CHANGES FROM BASE PRODUCT BE-L1003 (2797) TO AC-063 (4925)

Assembly PI Approval C.PURT	Approved by B.CHILDS		Checked by L.BRAR		Drawn by P.MISSEN	
	Angle of Projection		Units mm	Scale N/A	Released 16/07/15	Assembly Ref -
			Status RELEASED			
			AC-063			
Third Angle		Part No 4925		BE-003145-00-15

VIEW A-A
CABLE BUILDUP

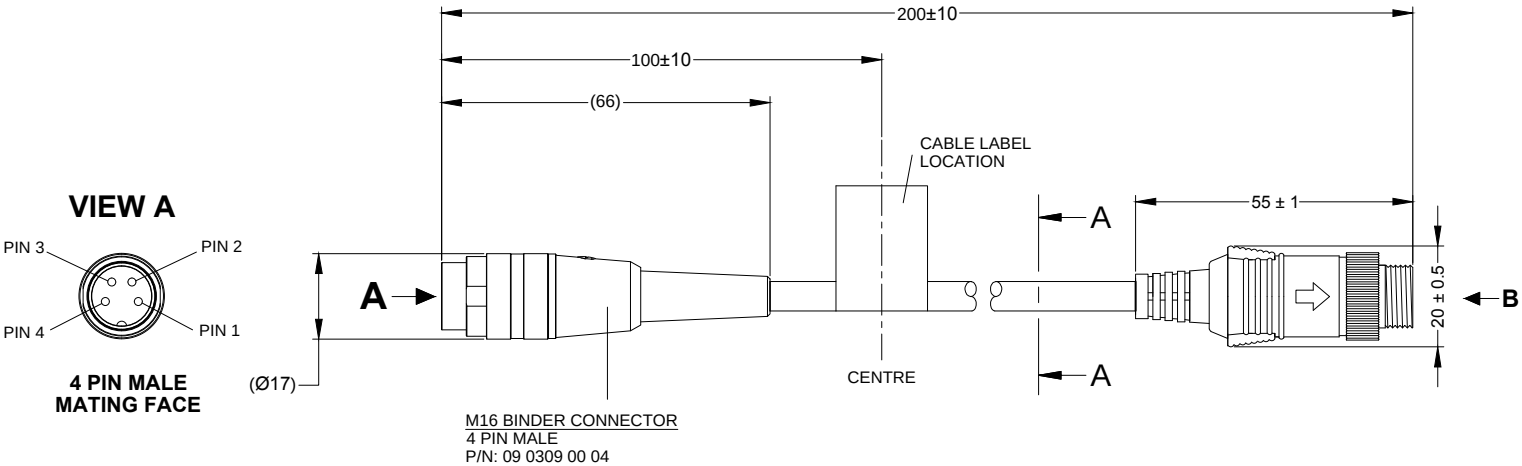
- CHANGE:
- 1. CUT CABLE TO REQUIRED LENGTH.
 - 2. REPLACE MALE CONNECTOR WITH 4 PIN MALE BINDER CONNECTOR.
 - 3. REPLACE GENERIC CABLE LABEL WITH AC-063 CB-LBL.
 - 4. REPLACE GENERIC GIFT BOX LABEL WITH AC-063 GB-LBL.
